H-11164

DESCRIPTIVE REPORT

Type of Survey HYDROGRAPHIC

General Locality NORTHERN CLARENCE STRAIT

Figure 1 H11164 Survey Limits

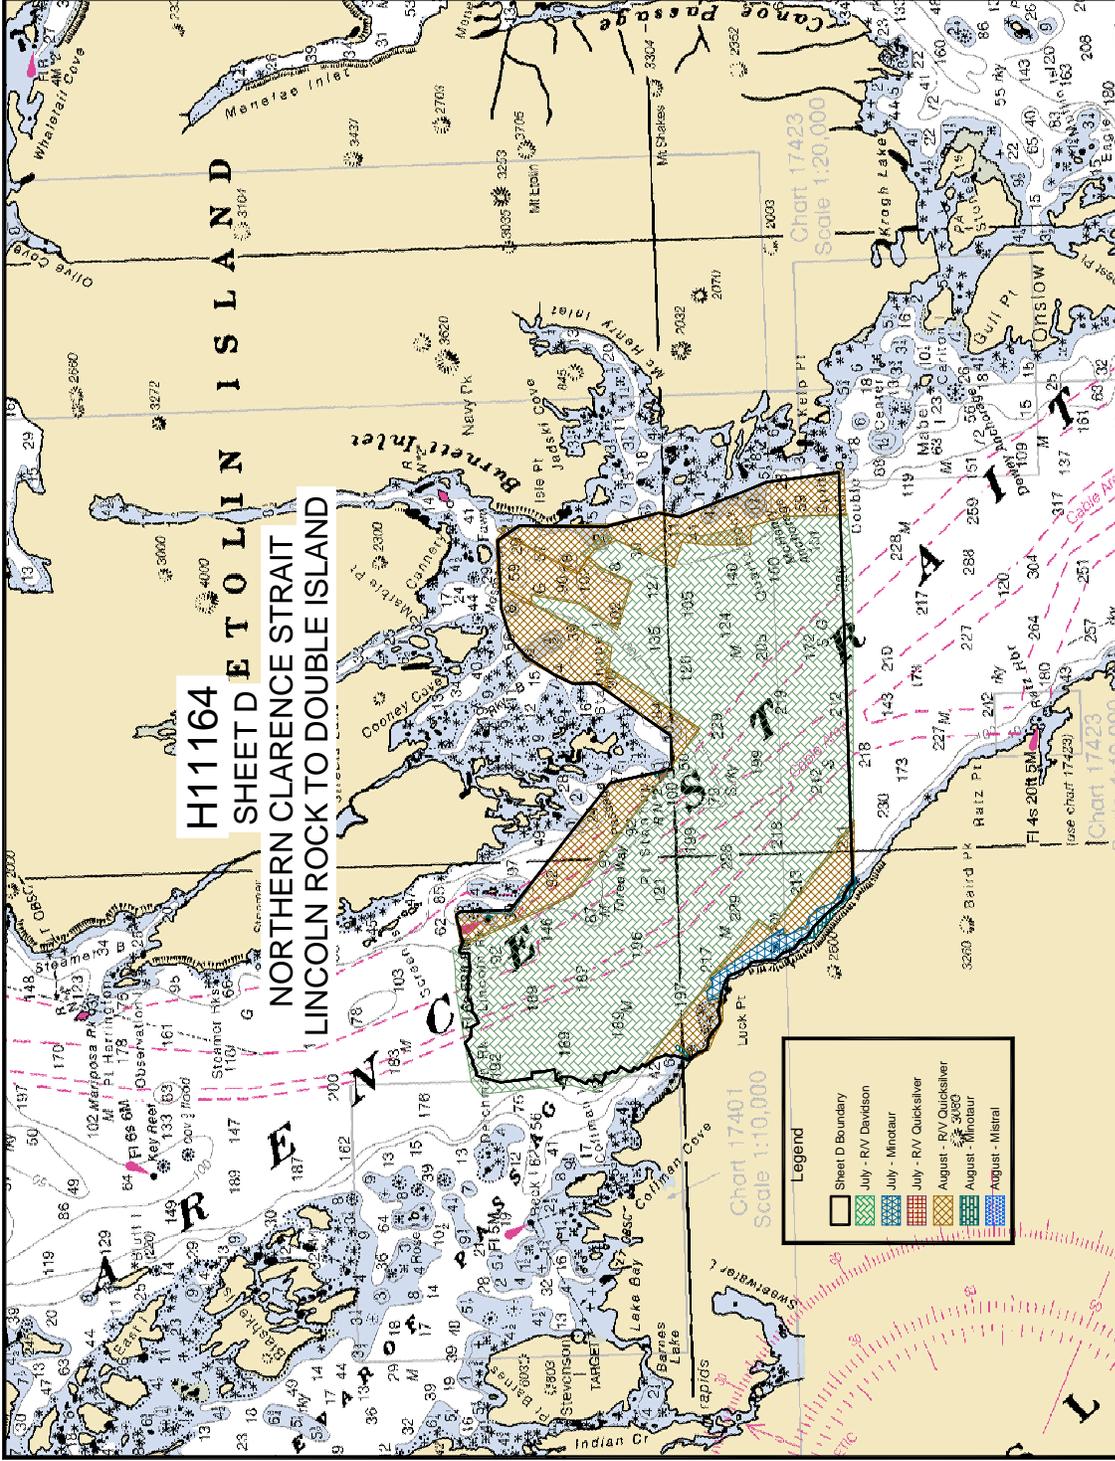
H11164 (Sheet D), is bounded by the coordinate listing below, and encompasses Lincoln Rock to Double Island.¹

Survey Limits³ Task Order # 10 H11164 Sheet D Scale 1:20,000		
Point #	Positions on NAD83	
	Degrees Latitude (N)	Degrees Longitude (W)
1	56°04'27.304" N	132°50'47.083" W
2	56°04'27.304" N	132°27'14.180" W
3	55°56'15.194" N	132°27'14.180" W
4	55°56'15.194" N	132°50'47.083" W

¹ Concur with clarification. The coordinates define the sheet limits. Refer to Surdex for the limits of the survey area. Lincoln Rock is east of the western survey limit and Double Island is outside the southeastern survey limit.

³ Concur with clarification. The positions given define the sheet limits. Survey limits are roughly defined by:
